**From:** [Tomas Barreto](#)  
**To:** [Luis Topete](#)  
**Cc:** [Ray Mueller](#); [SMC SupMueller](#); [Maria Gonzalez](#); [Bharat Singh](#)  
**Subject:** RE: URGENT: Clarification of Infrastructure Impact & Formal Objection to File No. PLN2025-00235 (1888 Cordilleras Road)  
**Date:** Monday, May 4, 2026 5:38:44 PM

I am writing to provide an update to my formal administrative objection regarding **Item #3 (PLN2025-00235)** on the May 7, 2026, Zoning Hearing agenda. I formally request that Item #3 be **pulled from the Consent Agenda** for public comment. I will be attending the hearing in person on **May 7, 2026, at 10:00 AM** to provide verbal testimony and enter physical exhibits into the permanent administrative record.

**Re:** Response to Public Comment of Tomas Barreto Regarding  
AT&T Small Wireless Facility in the Public Right-of-Way  
**CRAN\_RSFR\_PAPK1\_05** (near) 1888 Cordilleras Road (PLN2025-00235)

Table 14 Maximum Sound Pressure Level (dBA) for Radio 4890HP with Fan 15

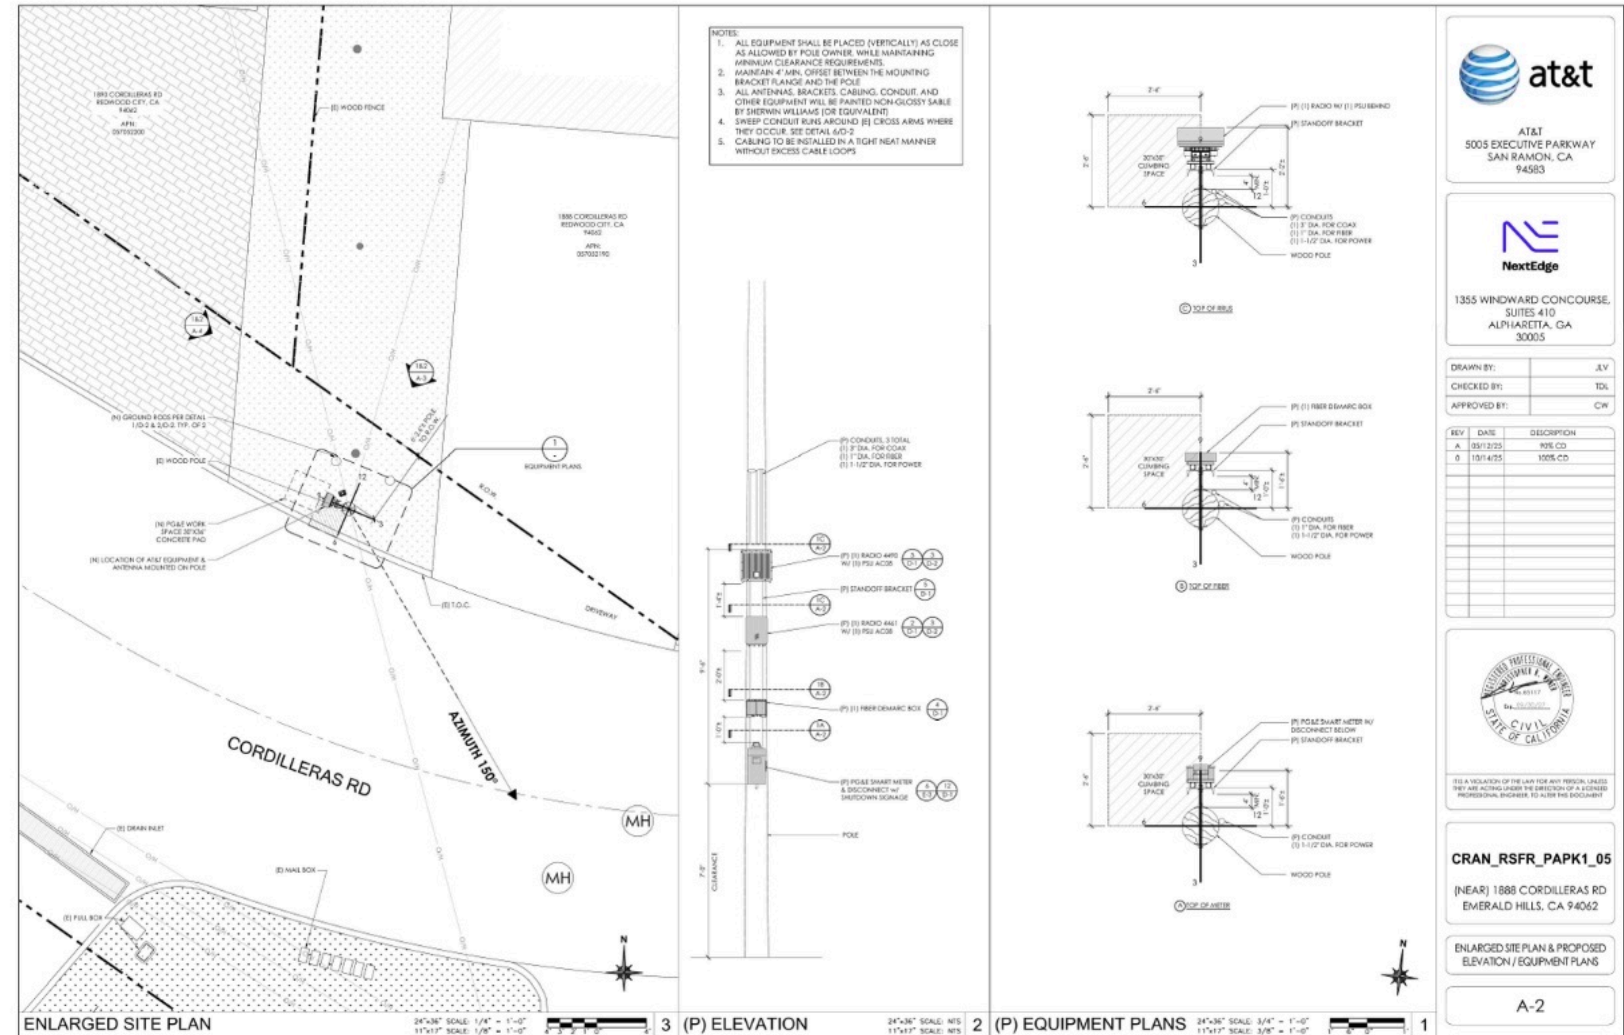
**II. Documented Noise Code Violation and Invalid Noise Study:** The Noise Assessment bases its compliance on hardware that is not on the plans. Using the applicant's own algorithm and the manufacturer data for the **Radio 4890** (which *is* on the plans), the site violates County standards:

- **At 25°C (77°F):** The 4890 produces **55.5 dBA** at 1 meter. At 6.29 feet, the noise level is **49.8 dBA** exceeding the margin of error of the report (from the applicant's noise study: "*Calculations contained in this report should be considered accurate to within one decibel*").

- **At 30°C (86°F):** The 4890 produces **57.5 dBA** at 1 meter. At the property line, this results in **51.8 dBA**, a direct violation of the **50 dBA nighttime residential limit** under Code § 4.88.320.

With the fan, the acoustic noise is ambient temperature dependent, as listed below.

**Second**, even if one were to apply the higher temperature-dependent fan-activated sound levels from the manufacturer’s specifications, the compliance conclusion does not change. The Ericsson specification data for the Radio 4490HP shows that at +25°C (77°F), the maximum sound pressure level with fan operation is 29 dBA at the loudest face (the back). The Radio 4461 (referenced in Appendix B as Radio 4467, which shares the same acoustic platform) shows 38 dBA at +25°C with fan. Even combining these higher values using logarithmic decibel addition and propagating them to the nearest property line at 6.29 feet, the calculated contribution remains well below the County’s 50 dBA nighttime residential limit under San Mateo County Noise Control Code § 4.88.320.

**Electrical Load Calculations @ 120V**

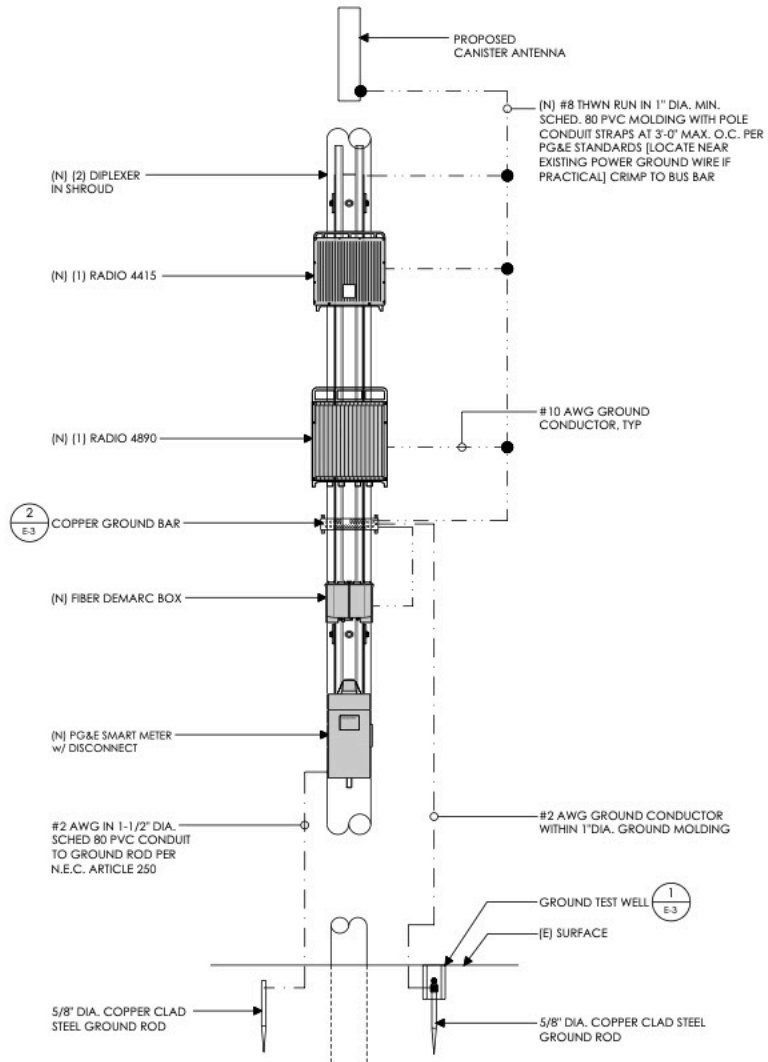
The applicant's claim that the Radio 4890 is merely 'reference material' is technically impossible, as it is the sole hardware used to calculate the **Total Site Load** on Sheet E-3 and the **Grounding Requirements** on Sheet E-2. If the 4890 is removed, the engineering basis for the entire site's electrical and safety infrastructure vanishes. I have included a PDF as Exhibit D as an attachment (showing all the hardware discrepancies).

- **Omitted Equipment:** The Noise Assessment Table 1 bases its 31.12 dBA projection on one **RRU 4461** and two **RRU 4490** units.
- **The Reality:** However, the Site Plan Scope and the Electrical Load Calculations both specify the installation of the **Radio 4490** and the **Radio 4890**.
- **Extreme Noise Delta:** The **Radio 4890** which is the actual hardware intended for the site is entirely missing from the noise calculation. Manufacturer specifications in the report confirm the 4890 can reach a sound pressure level of **73.5 dBA** when its fans are active.
- **Inaccurate Projections:** Relying on a "worst-case" study that ignores the loudest piece of equipment on the site plan is a material error.

During the design development phase, AT&T refined the equipment configuration for sites PPK1\_04 and PPK1\_05. The initial construction drawings prepared in May 2025 depicted an Ericsson Radio 4890 (Model RRHS-4890 B25/B66) as one of the proposed Remote Radio Units. That unit was subsequently replaced with an Ericsson Radio 4461 as part of standard design optimization, and updated construction drawing sets were finalized on **October 14, 2025** at the 100% Construction Document milestone.

Due to an administrative oversight during a project manager transition, the October 14, 2025 drawing sets were completed internally but were not transmitted to the County Planning Department. The superseded May 2025 versions consequently remained in the application files and were referenced in the staff reports for PLN2025-00234 and PLN2025-00235. The community comments submitted for PLN2025-00235, while carefully constructed, were based on these superseded drawings and therefore attributed hardware to the project (the Radio 4890) that is not proposed for installation at either site.

PROPOSED SIDE ELEVATION

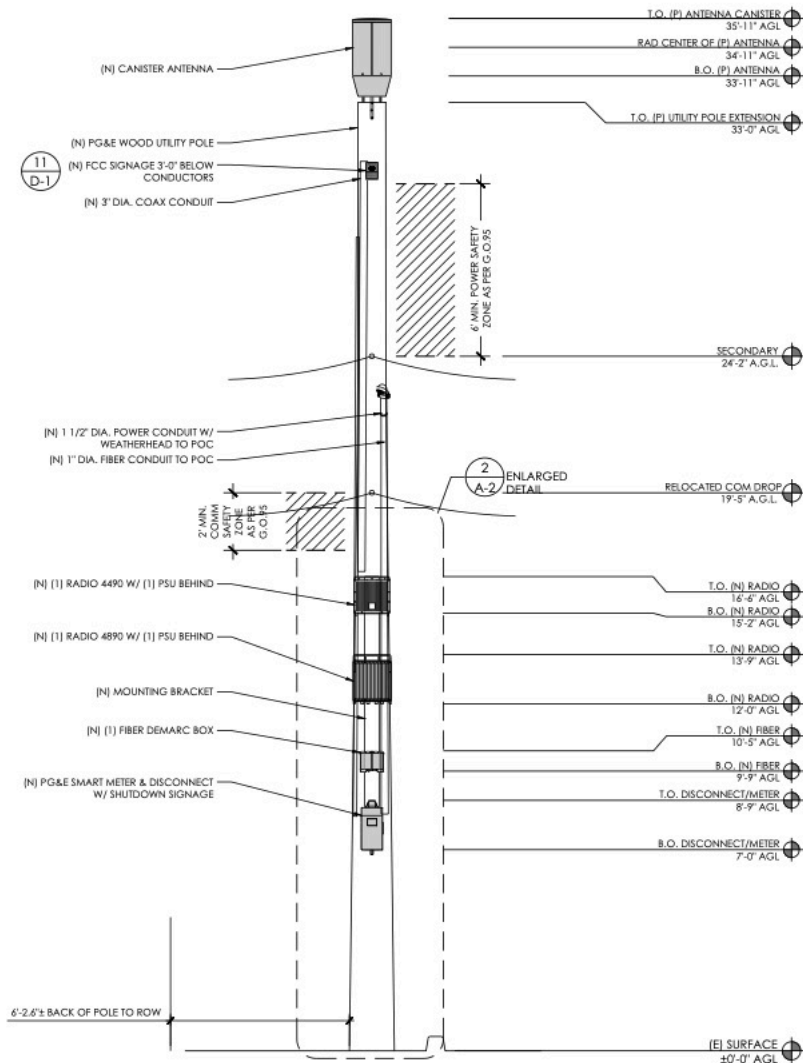
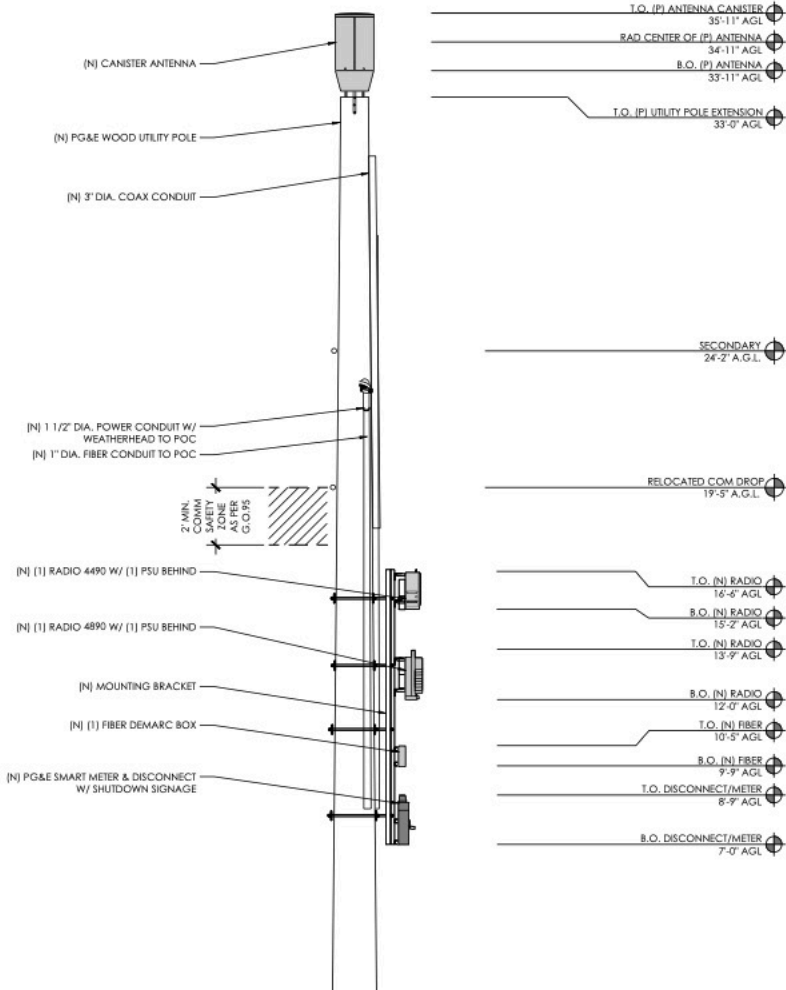
- Title Sheet (T-1): The project scope explicitly states: "Install (2) New Radio 4490 and Radio 4890".
- Elevations (A-3): Explicitly labels "(N) [1] Radio 4890 w/ [1] PSU Behind" .
- Side Elevations (A-4): Again labels "(N) [1] Radio 4890 w/ [1] PSU Behind".
- Equipment Details (D-1): Detail 5 is titled "Radio 4890" and provides mechanical specs for that unit .
- Grounding Schematic (E-2): Explicitly labels the connection for "(N) [1] Radio 4890".
- Electrical Load Calculations (E-3): Detail 10 uses the Radio 4890 (listing 1109W and 11.6 Amps) to calculate the total site load .

- **Title Sheet (T-1):** The project scope explicitly states: "Install (2) New Radio 4490 and **Radio 4890**".
- **Elevations (A-3):** Explicitly labels "(N) [1] **Radio 4890** w/ [1] PSU Behind" .
- **Side Elevations (A-4):** Again labels "(N) [1] **Radio 4890** w/ [1] PSU Behind".
- **Equipment Details (D-1):** Detail 5 is titled "**Radio 4890**" and provides mechanical specs for that unit .
- **Grounding Schematic (E-2):** Explicitly labels the connection for "(N) [1] **Radio 4890**".
- **Electrical Load Calculations (E-3):** Detail 10 uses the **Radio 4890** (listing 1109W and 11.6 Amps) to calculate the total site load .

Document	Reference Location	Equipment Specified
Title Sheet (T-1)	Project Scope / Description	Radio 4490 and Radio 4461
Equipment Details (D-1)	Detail 3 and Detail 5	Radio 4490 (or Approved Equal) and Radio 4461
Electrical Load Calculations (E-3)	Detail 10	Radio 4490: 989W, 10.3A Radio 4461: 240W, 2.5A
One-Line Diagram (E-2)	Grounding Schematic	Radio 4490 and Radio 4461
Elevations (A-3, A-4)	Front and Side Elevations	Radio 4490 w/ PSU and Radio 4461 w/ PSU
Noise Assessment (Table 1)	Proposed Equipment	Ericsson 4461 (36 dBA) and Ericsson 4490 (26 dBA)

**Six independent documents in the application record uniformly identify the Radio 4490 and Radio 4461 as the proposed equipment.** The Radio 4890 does not appear in any project scope, any equipment plan, any electrical calculation, any elevation drawing, or any equipment specification detail in the construction drawing set.
